CHANGES AND ADDITIONS
TO THE FOLLOWING PARTS BULLETINS

<u>Model 14 Printers</u>	<u>Model 14 Typing Reperforators</u>	<u>Model 14 Non-Typing Selectors</u>	<u>Model 14 Typing Reperforator Transmitter</u>	<u>Multiple Reperforator</u>
1028 Issue 2	1082 Issue 2	1083 Issue 1	1108 Issue 2	1130 Issue 1
1030 Issue 2	1088 Issue 2	1107 Issue 1	1126 Issue 1	
1031 Issue 3	1100 Issue 2	1116 Issue 1		
	1117 Issue 2

LOWER PORTION OF MAIN SHAFT CASTING

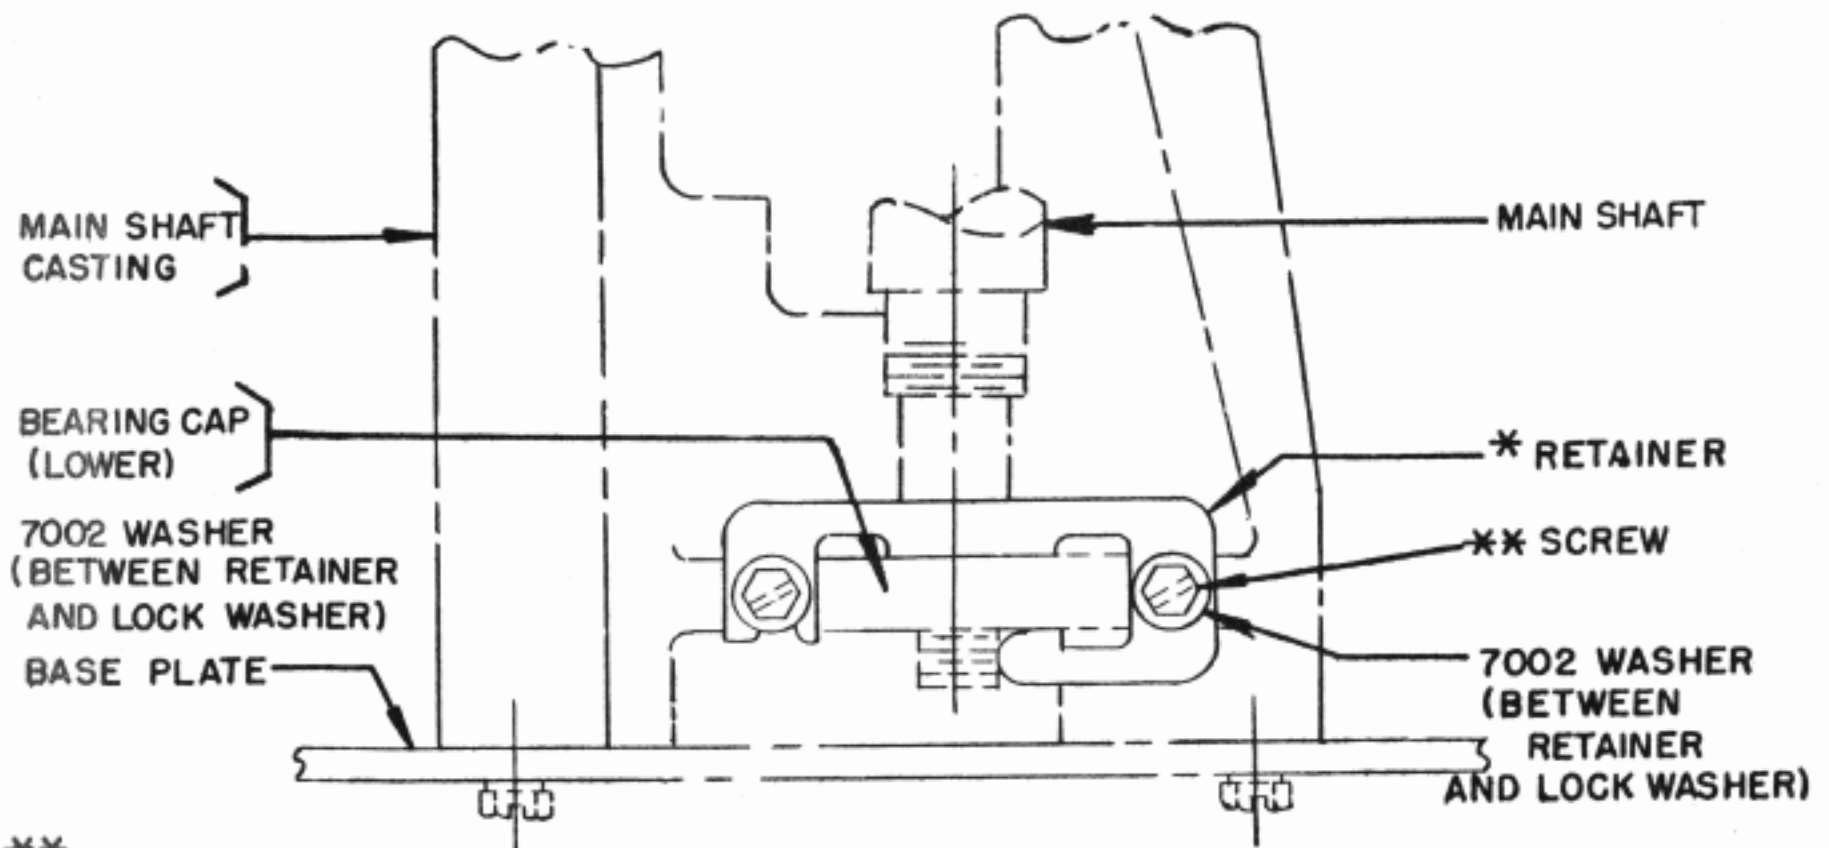
On units operating at high speed or after prolonged use, the main shaft shown in the above bulletins may have a tendency to shift under the bearing caps.

In order to prevent this, two 7002 washers have been added on the upper bearing cap; two 7002 washers and a * retainer have been added on the lower bearing cap and should be mounted as shown below:

- * 120895 retainer (for Bulletin 1130 only)
- * 117387 retainer (for all other bulletins)

** Units with serial numbers lower than 70,000 require 105960 screws (6-40 x 11/16) in place of the 72508 (formerly 6811-6-40 x 5/8) screws (6-40 x 3/4). When the threads of the tapped holes in the 7610 main shaft bracket become damaged a 124613 steel insert may be ordered.
